In Response to: ExQ1 Number 1.12.3

West Midlands Interchange

Note in response to ExAQ1.12.3

drawing title
Landscape Features Retained and Removed

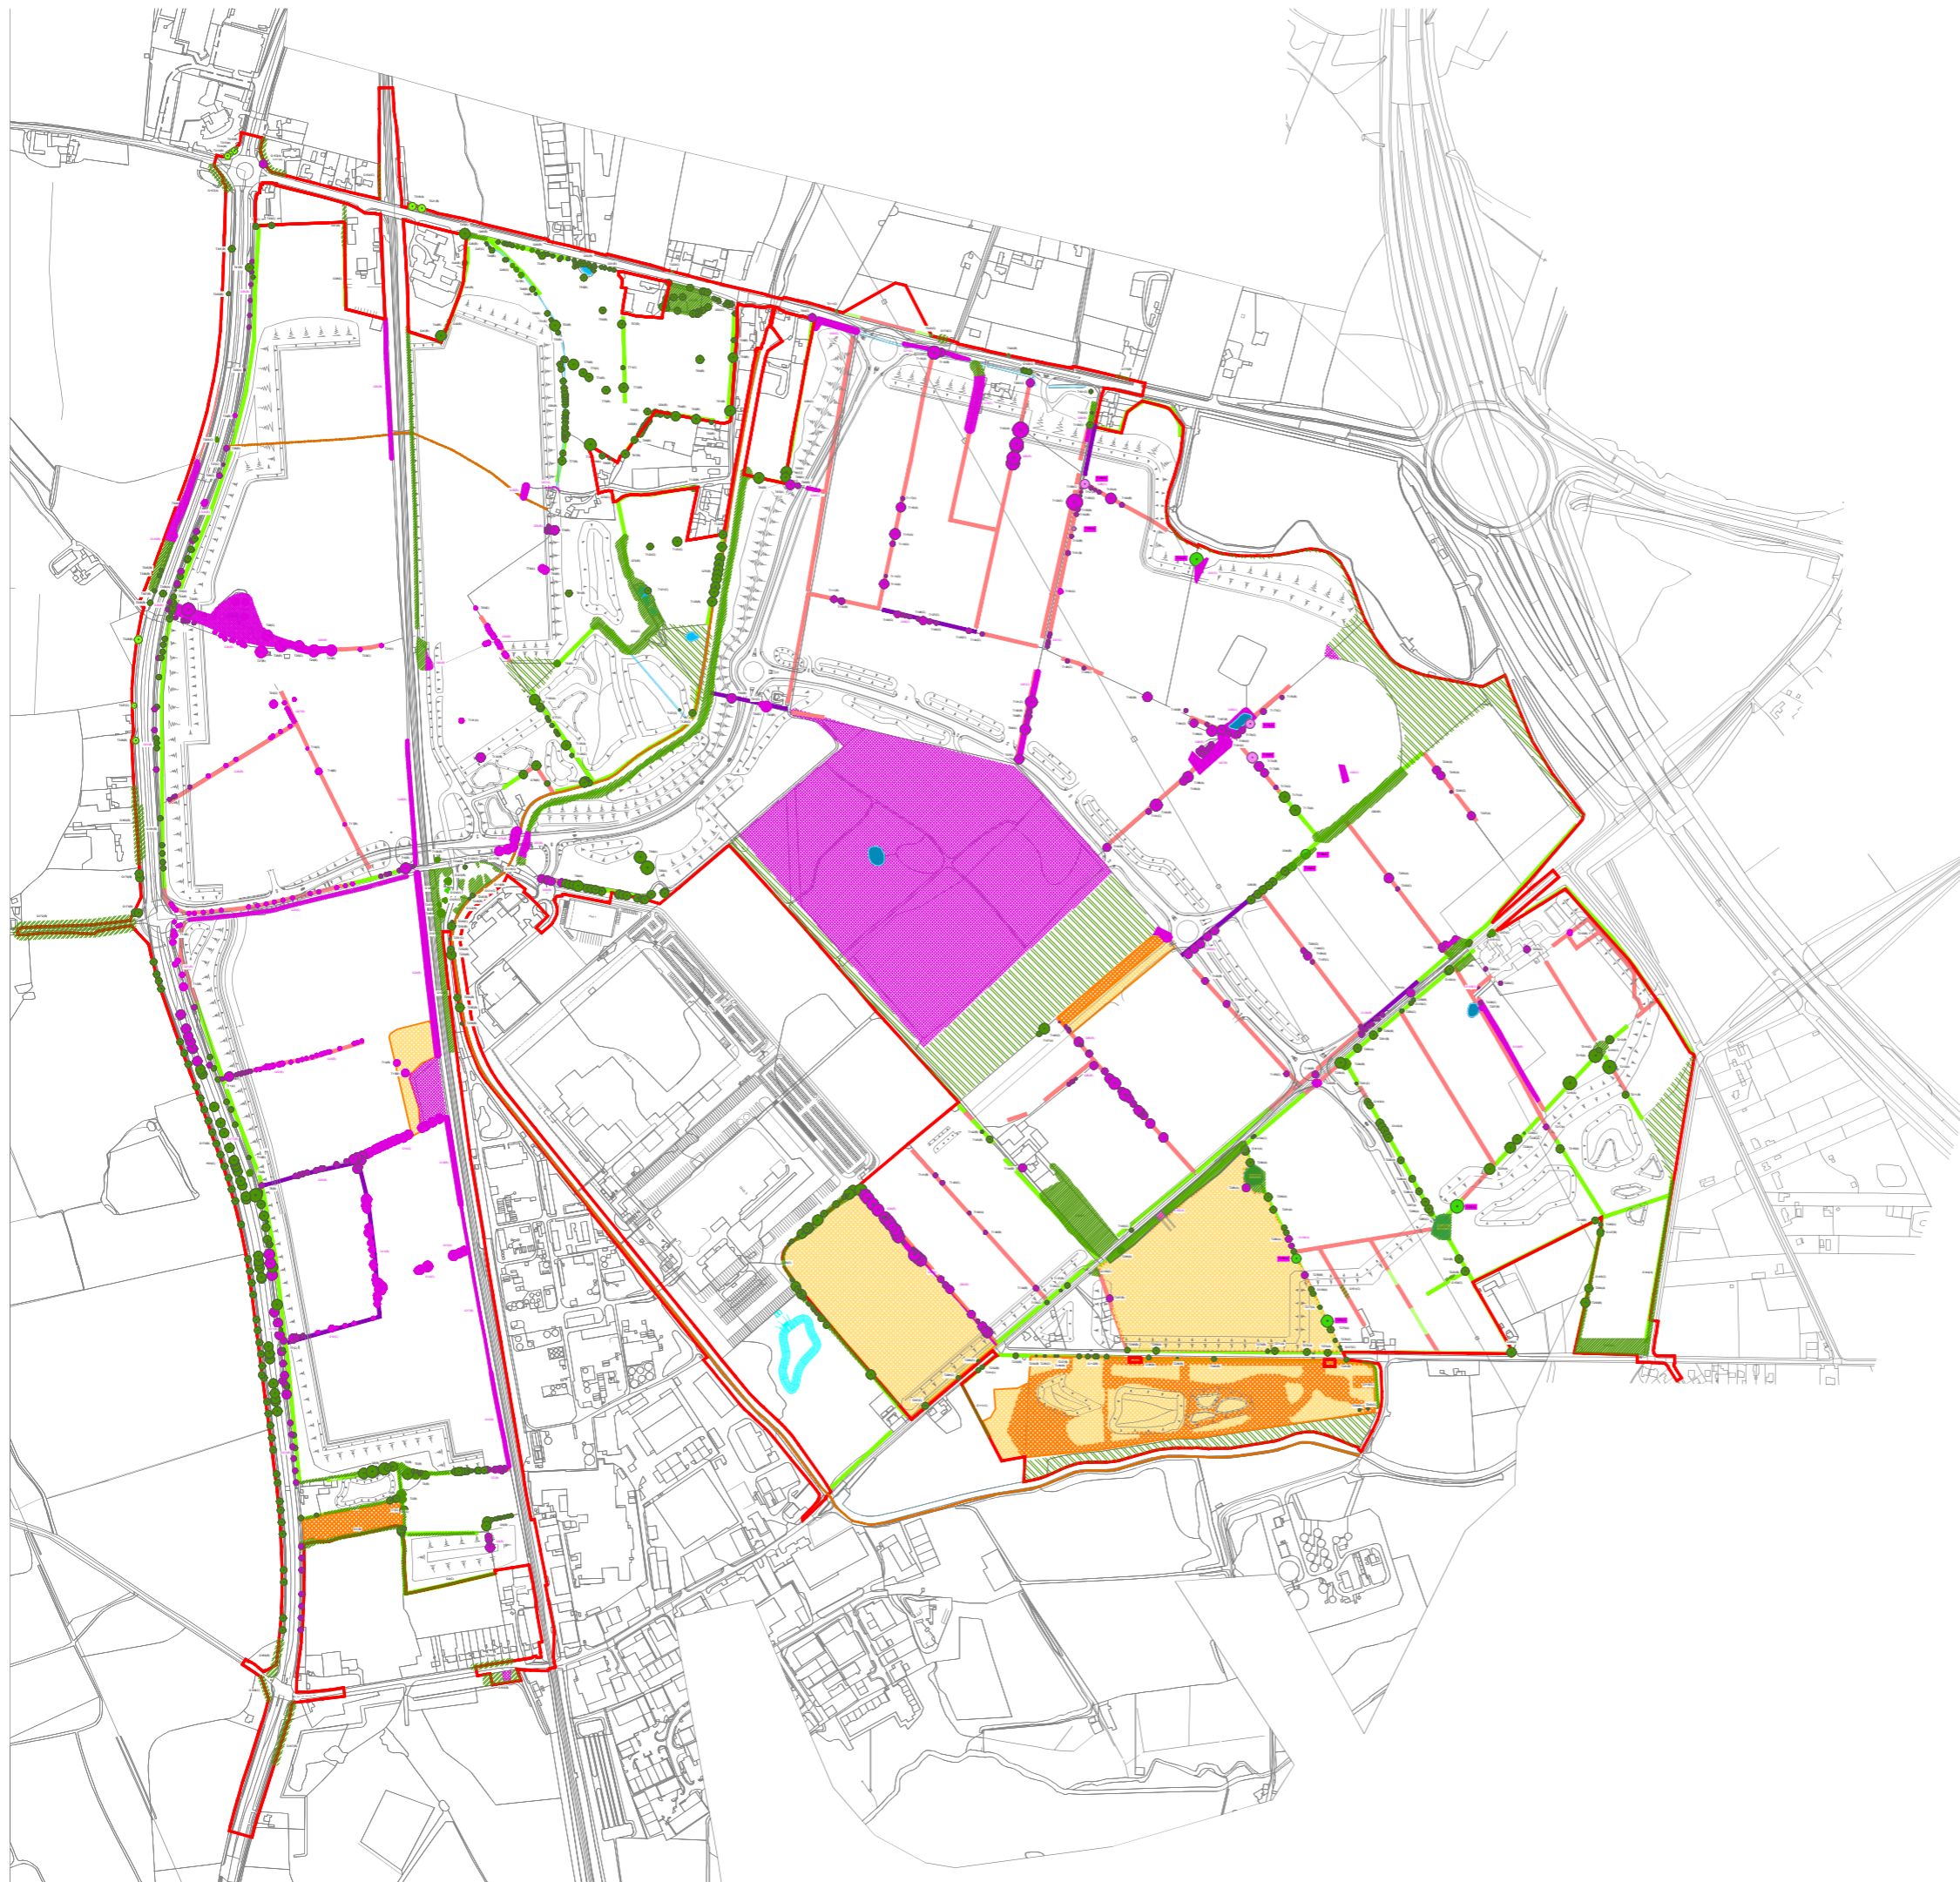
Table 4 of the Arboriculture Assessment sets out detailed data as to the numbers of individual trees, tree groups, lengths of hedgerows and areas of woodland to be retained within the Proposed Development and to be either fully removed or partially lost to facilitate the development. However, there appear to be a number of discrepancies (in all categories) between this data and that set out ES Appendix 12.9 [APP-107] which purports to set out the overall effect of the proposal including the proposed new planting.

(i) Please can the Applicant check these two sets of data and confirm which is correct?

(ii) Having done so, can the Applicant provide a short note confirming what the overall effect of the Proposed Development would be and identifying to what extent net gains would be achieved in each of these categories?

- 2.3 There are discrepancies between some of the related quantities in these two documents. This principally arises as the baseline survey for the Arboricultural Assessment includes some existing woodland and trees that lie beyond the Site boundary. For example, Table 4 of the Arboriculture Assessment includes all of Calf Heath Wood, whereas a sizeable proportion of the existing woodland on its western side (circa 7.8 ha as included within Table 4) lies outside the Site. There are also a number of tree groups and individual trees generally located on and around the Site boundary that differ between the two respective Tables.

- 2.4 In relation to the discrepancies between the lengths of hedgerows and tree group numbers, this also arises in part due to differences in the categorisation of these planting types. The Summary of Landscape Areas and Habitats at ES Technical Appendix 12.9 adopts the existing hedgerows as identified in the Ecological Assessment (Doc 6.2; Chapter 10; Appendix 10.1) as the basis for the estimating the total lengths. This includes some differences from those identified in the Arboricultural Assessment, where some hedgerows are instead identified as tree groups. This generally occurs where hedgerows are outgrown and/or unmanaged and can thus also be fairly categorised as a tree group.

- 2.5 The area of woodland and numbers of tree groups and trees is thus based upon the Arboricultural Assessment (now amended to reflect the Site extents), and the lengths of hedgerow are based upon the Ecological Assessment.

- 2.6 To clarify the position and following a review of the data, the Summary of Landscape Areas and Habitats and the accompanying plan (Landscape Features Retained and Removed (Drawing No. 7121-L-11) (both included at Doc 6.2; Technical Appendix 12.9) have been updated. The Summary of Landscape Areas and Habitats is now dated 26 March 2019 and the updated Drawing is 7121-L-11 Rev F.
